Groundwater Transfer Review Summary Form

Transfer/PA # T- 13860

Application: T-13860

Applicant Name: Stauffer Farm Inc.

Drawdown calculations for MARI 69905 impacts to neighboring MARI 51008 at currently authorized rate of 0.673 CFS. Increases in rate at this proposed APOA may result in injury to neighboring right Certificate 92328.

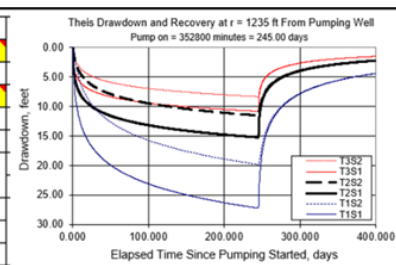
4. a) Will this proposed change, at its maximum allowed rate of use, likely result in an increase in interference with **another ground water right**?
 Yes No Comments: The largest expected net change in pumping due to the proposed changes is the newly added MARI 69905. MARI 51008 authorized under Certificate 92328 is the nearest well to proposed APOA MARI 69905, at a distance of 1,235 feet.

MARI 69905 is currently authorized under Permit G-18537 at a maximum rate of 0.673 CFS, limited by the 80% exceedance flow in the resident WAB. Using parameters included in the original application review (G-18923; Travis Brown), an increase in pumping as a result of this transfer is likely to cause injury at MARI 51008, with expected seasonal drawdowns between 15-50 feet. If the maximum rate at MARI 69905 is maintained at the authorized rate under G-18537, however, the most reasonable estimates of drawdown lie between 11-16 feet. In addition, MARI 69905 is proposed as an APOA on GR Modification T-13861, where it, and a combination of other existing wells are replacing abandoned POA MARI 1016.

7. What conditions or other changes in the application are necessary to address any potential issues identified above: To avoid injury with nearby rights, proposed APOA MARI 69905 shall be limited to its previously authorized rates under Permit G-18923 and GR-751 for a total of 1.23 CFS.
